THE COLONG FOUNDATION FOR WILDERNESS LTD.

Tuesday December 13th, 2016

Submission regarding Western Coal Services SSD 5579 Mod 1

Figure 1 - Revised Cooks Dam/Wangcol Creek hydrological model to include significant cumulative impacts of leachate from various waste heaps on project site groundwater.

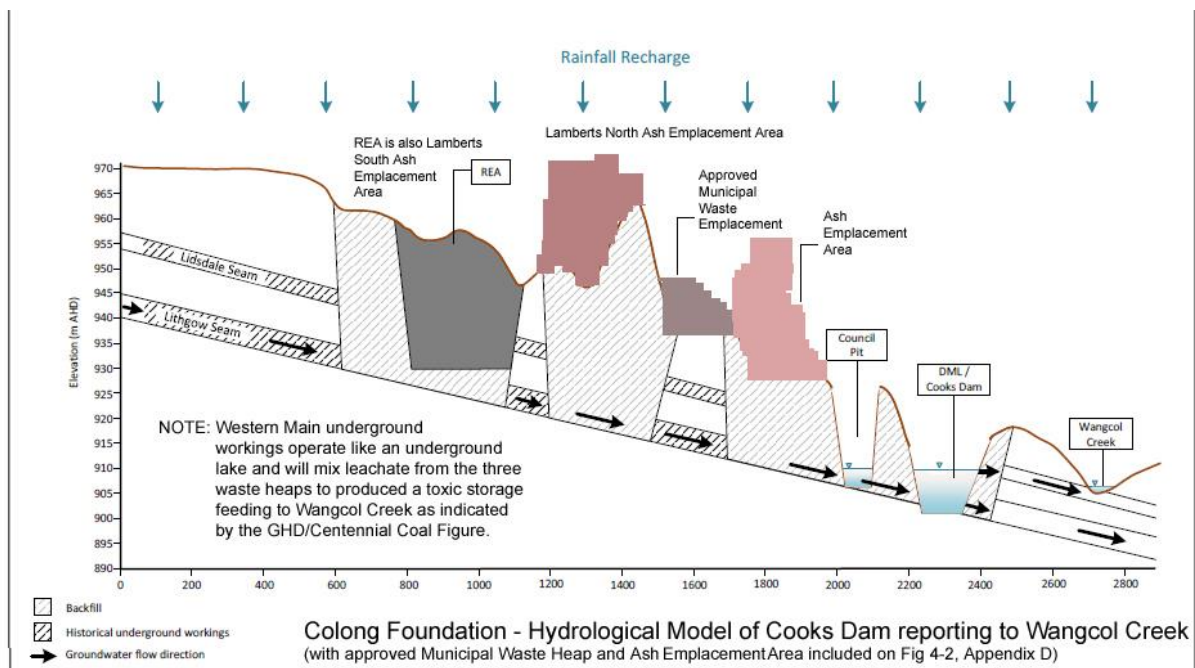
The Department of Planning and Environment must require the water and salinity load modelling to be redone with the cumulative impacts within the project area to be fully accounted for, as the likely consequences of these impacts are likely to greatly magnify the already large salinity problem associated with LDP006. Salinity levels at Cooks Dam discharge, LDP006, already approaches 5,000µS/cm.

The modelling analysis for the proposed minor works modification combines the beneficial outcomes from the treatment and power plant reuse of Springvale mine water from LPT009 with the adverse saline discharge from LTP006, to predict favourable cumulative downstream flows and salinity outcomes. While the cumulative assessment for this modification proposal is done for the downstream environment, the cumulative water input flows and salinity assessment is not done *for* the project area. This selective cumulative modelling assessment of the proposed modification creates an unreasonably favourable outcome that cannot eventuate as saline inputs from the ash and REA waste emplacements are omitted from the model.

Figure 2 shows extent of shallow old mine workings and open cut mines that make the project area porous and ensures that groundwater controls the water balance of the project area.

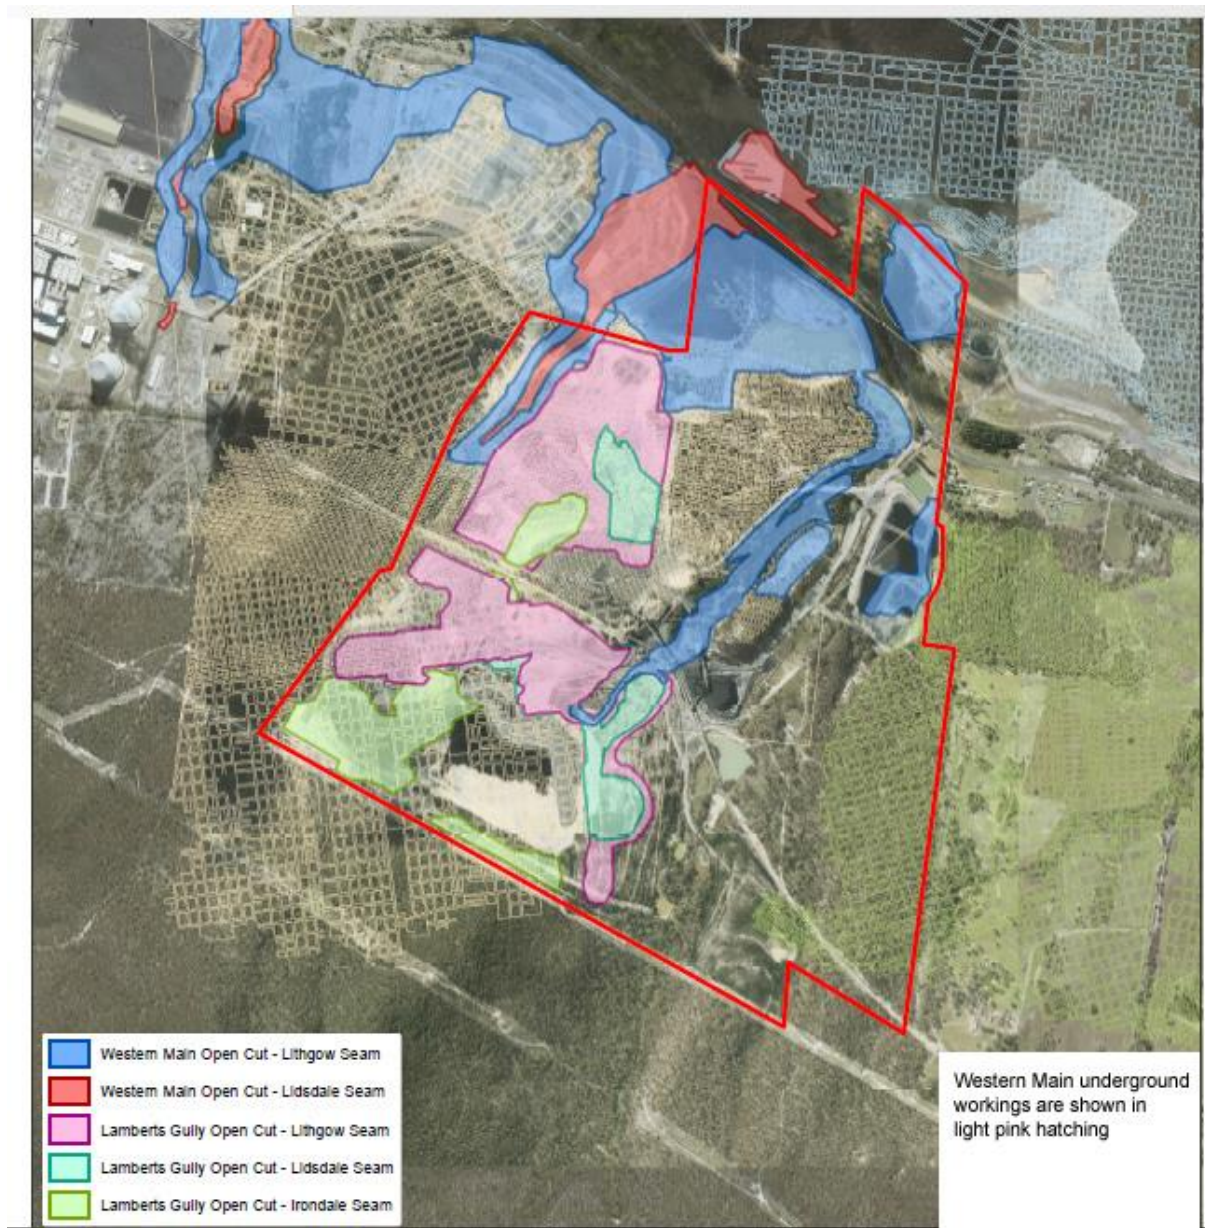
Groundwater is interconnected through the old bord and pillar workings of the Western Main mine, (see *figure 2*). The “clean” groundwater may “float” on top of the denser more saline groundwater within the mine workings. Such saline groundwater behaviour has implications for monitoring and management if it commences to report to Wangcol Creek in considerable volume.

Figure 3 The water transfer schematic does not explain that the 'Groundwater Environment' receives large inputs from the extensive waste heaps in the project area, not just the REA but also the ash emplacement areas, and possibly metropolitan waste area.

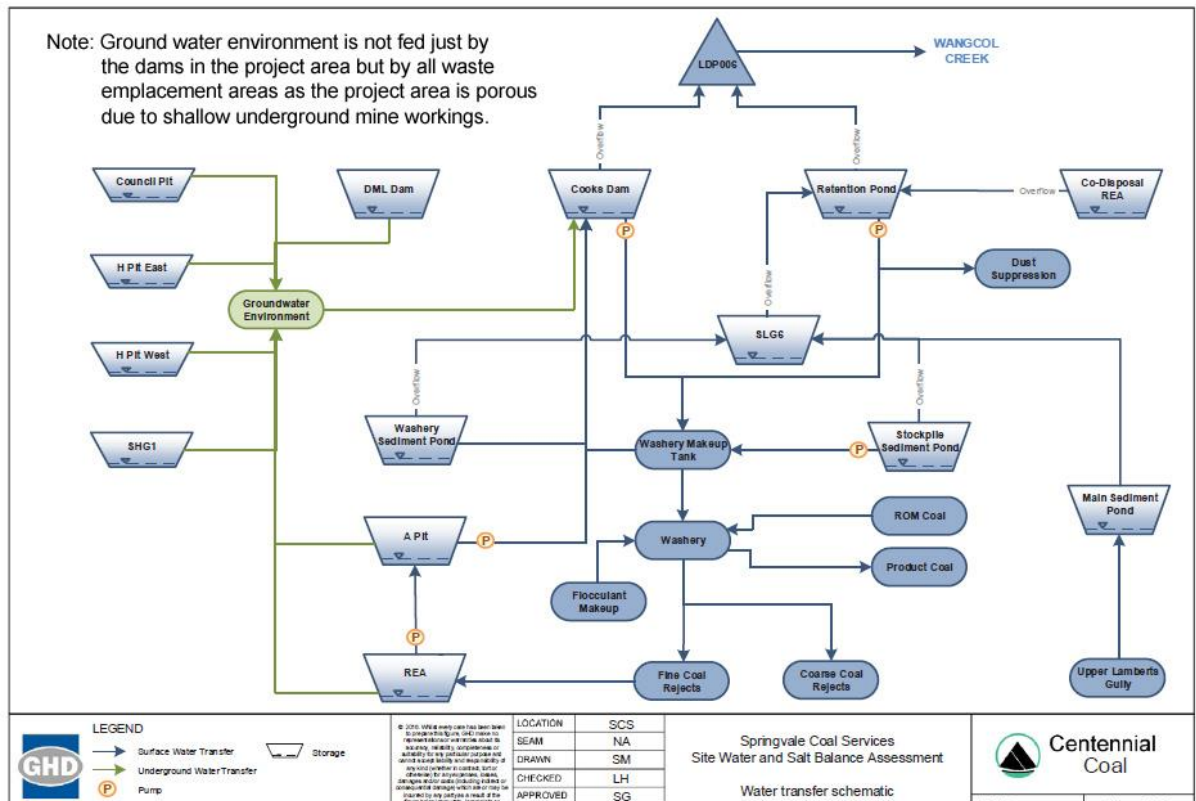
The modelling assessment admits that mine water from old underground mine workings will find its way to LPT006 through Cooks Dam to Wangcol Creek (see *Figure 3 modelling schematic*) but ignores the large non-point groundwater discharges from the project area (see *additional Figure A* at the end of this submission).

The lower part of the proposed “clean” catchment surrounds appears to be separated from the Co-disposal REA. This REA is described in the text on page 28 as having six cells. The two eastern cells are described as holding decant water, however *figure 3* shows decant water from these cells going to LDP006.

The regulation and treatment of contaminated groundwater within the project area is not investigated by the SEE. Ground water collection at Cooks Dam seems the most favourable option for its collection and subsequent treatment according to the schematic below (see *Figure 3*).

Additional Figure A – Saline groundwater – a growing non-point source of Wangcol Creek pollution.

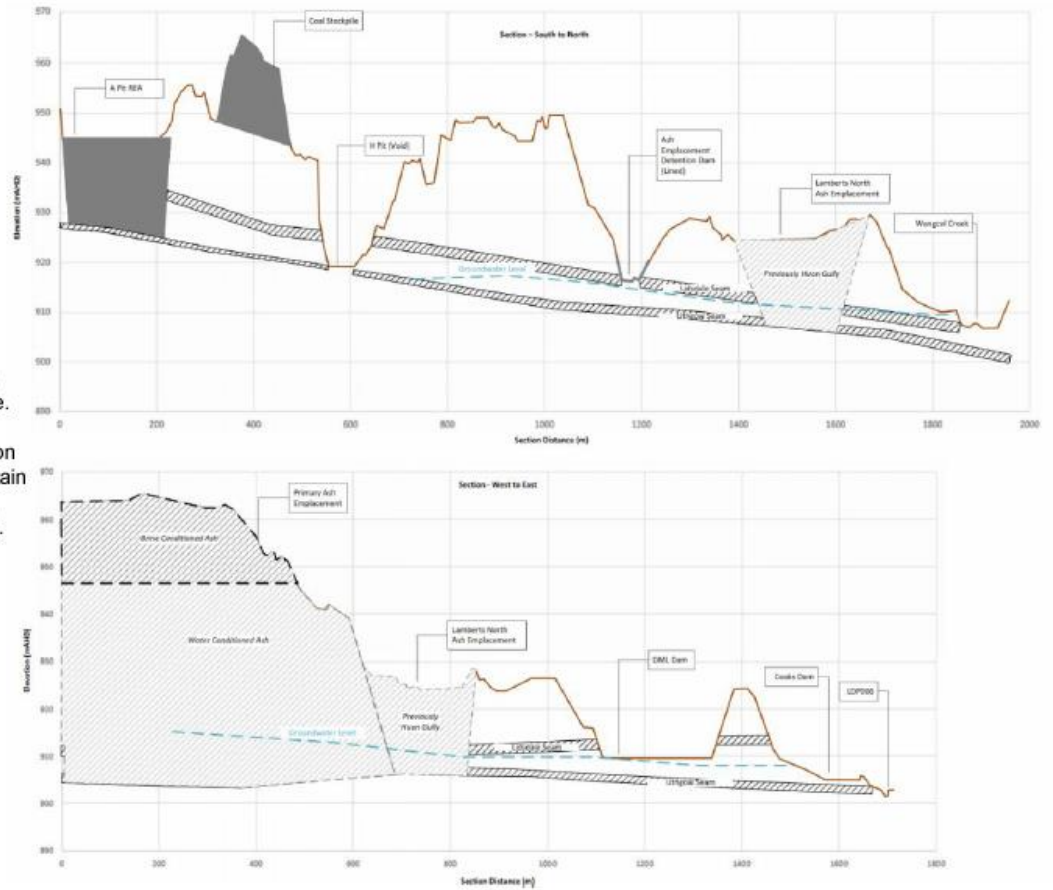
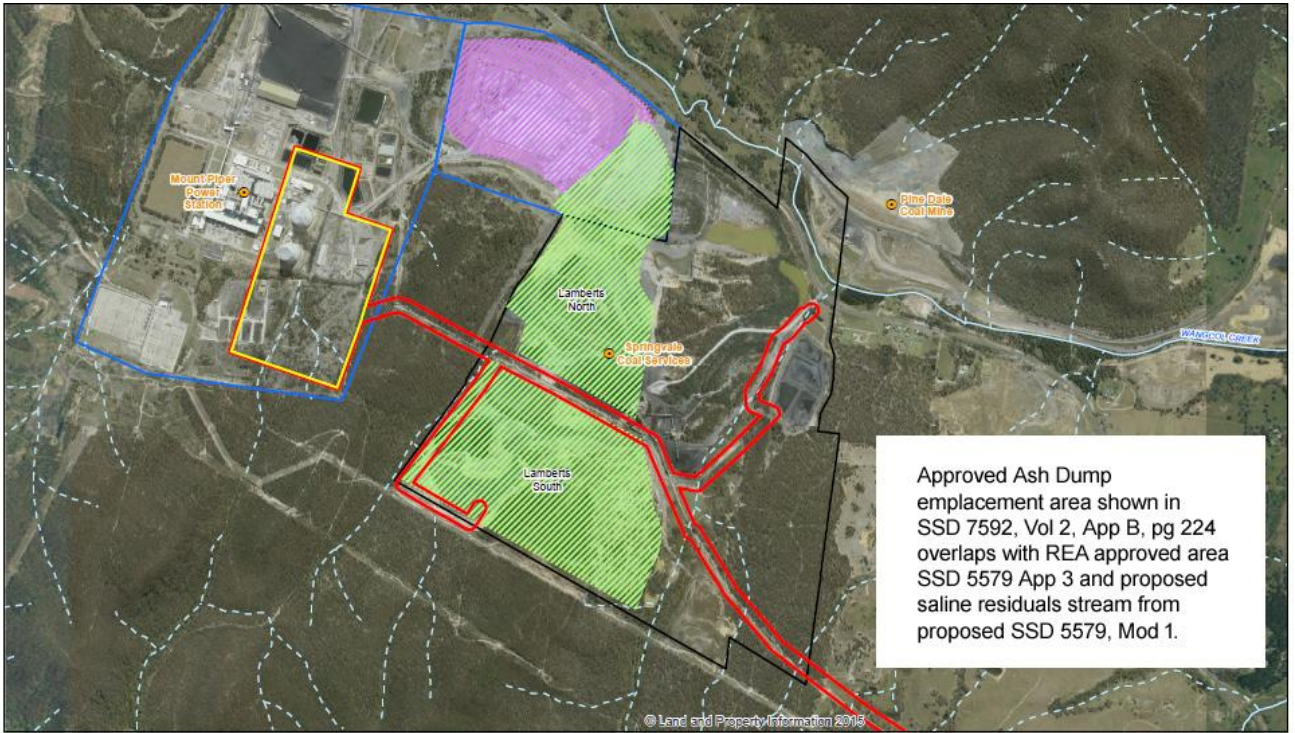
This ability of Cooks Dam to collect contaminated groundwater should be subject to further investigation. *Additional Figure A* indicates that Cooks Dam *does not* collect all saline groundwater.

Further, surface salinity monitoring data for Wangcol Creek demonstrates salinity increases from the Newbecks Creek junction to the Wangcol Creek gauge station to 585µS/cm (see Table 5-3, Vol 2, Appendix D of SEE) and again to the Wangcol Up Stream sampling site that read 2,577µS/cm, compared to LDP006 reading of 4,722µS/cm (Table 5-9, Vol 2, Appendix D of SEE, both sampled May

2016). These data when read with the groundwater cross section suggests that LDP006 does not collect all saline groundwater from the project site.

NOTE: location of
groundwater and
Wangcol Creek.

Entire project
area subject to
open-cut or
bord and pillar
coal mining.

Implications for pollution
control of salinity are dire.

Non-point salinity pollution
of Wangcol Creek is certain
to increase unless
groundwater intercepted.

The project area groundwater must be further investigated to determine the proportion of saline groundwater that can be monitored and treated at LDP006. For example, it may be possible to control non-point groundwater discharges reporting to Wangcol Creek by a grout barrier or by management of storage levels in Cooks and DML dams at lower storage levels.

Additional Figure B - shows approved brine modified ash emplacement overlaps – Lamberts South - with approved SCSS REA as shown in Addition Figure C below, which all overlap with the proposed residuals emplacement from the water treatment plant.

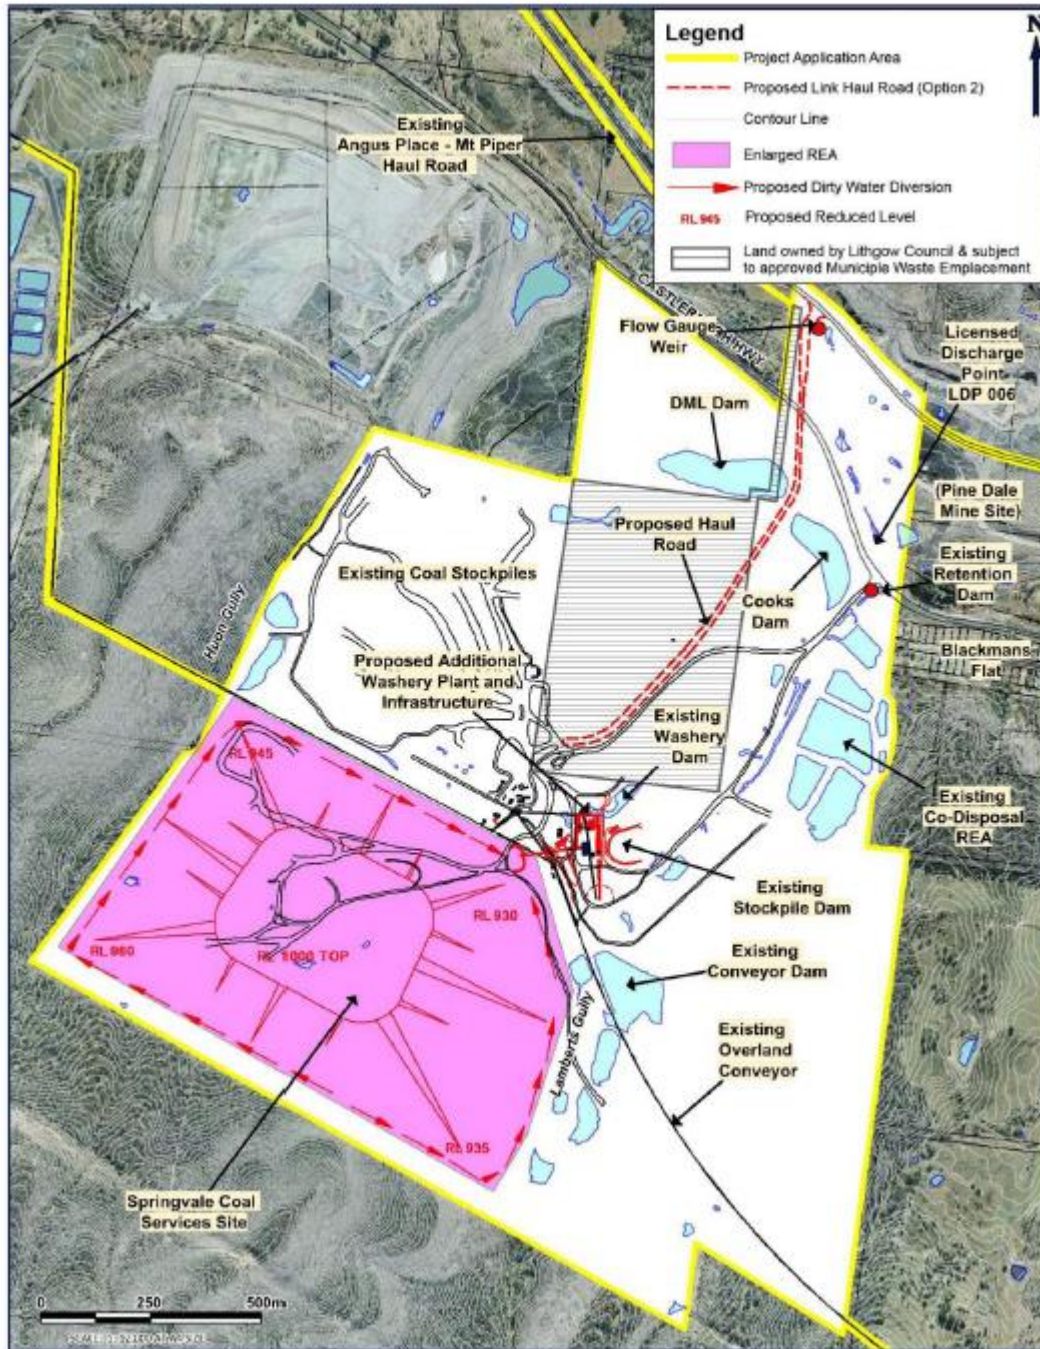
The placement of water treatment residuals in the *existing* ash emplacement area is restricted. The brine conditioned ash is placed above the water conditioned ash, but this practice does not appear to be a consideration in the proposed modification in relation to combined REA/ash emplacement.

The SEE states that 'the water balance modelling predicts an increase in the volume of water discharged through LDP006 as a result of the increased load on the SCSS water management system due the residuals transfer.' The saline load on Wangcol Creek must increase as LPT006 receives discharges from three types of waste. The effect of mixing leachate from coal reject, ash emplacement and the water treatment plant residuals is possibly synergistic but not considered by the SEE.

NOTE: Location of Municipal Waste Emplacement to SCSS site, DML & Cooks Dams

Addition Figure C - shows size of SCSS site where co-disposal is proposed for saline residuals and large size of metropolitan waste emplacement area relative to it and the coal washery.

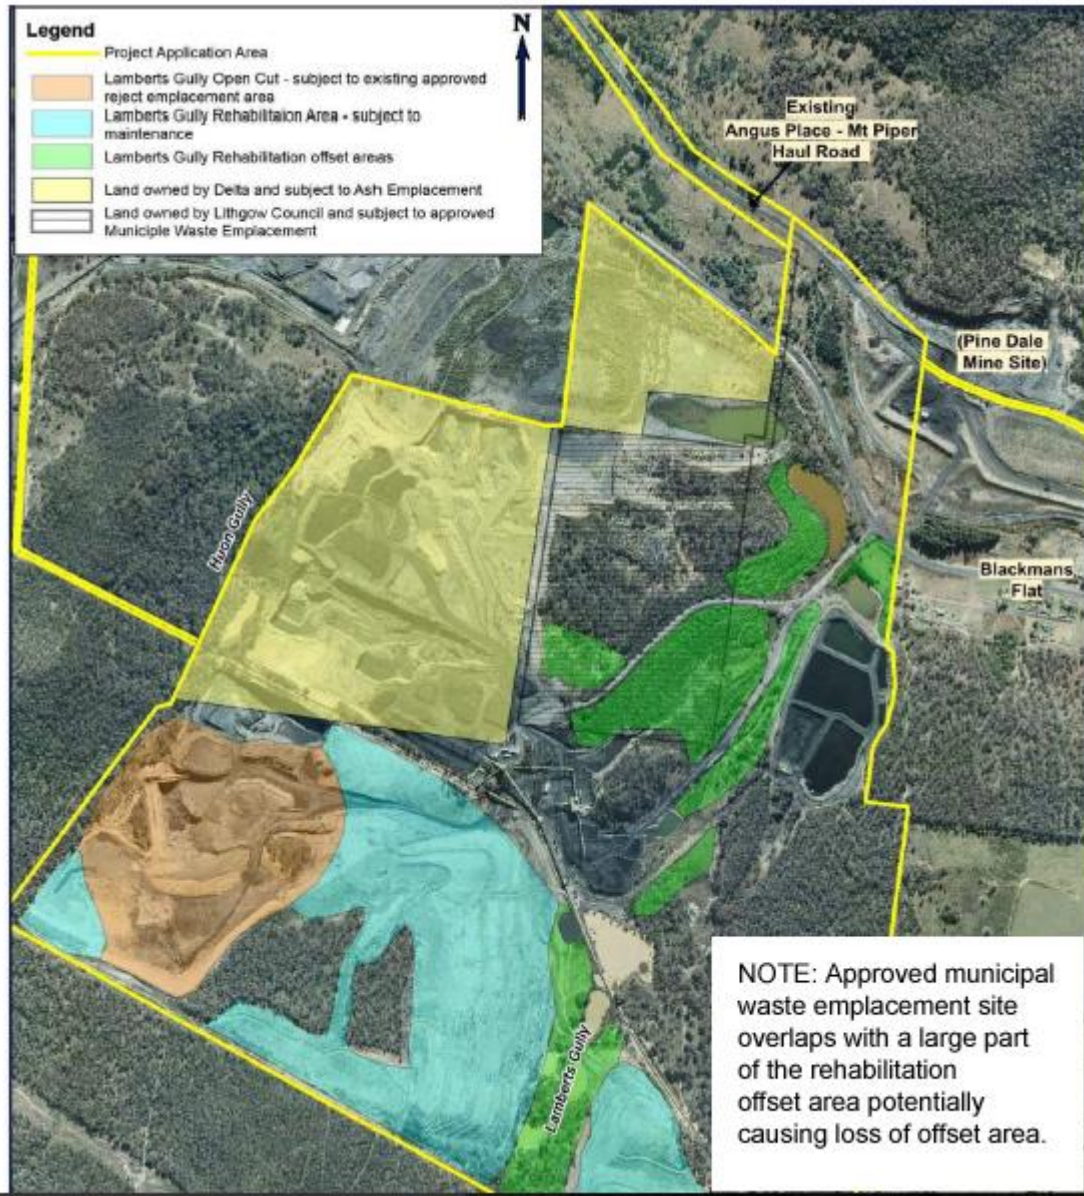
Municipal waste dump development also will replace a large part of the “Lamberts Gully Rehabilitation offset areas” (see *additional figure D*). Loss of this offset appears not to be accommodated by further offsets, and is a poor practise, as ecosystems can’t be traded as commodities without unexpected ecological outcomes.

Additional figure D – a rehabilitation offset is to be replaced by a large municipal waste heap.
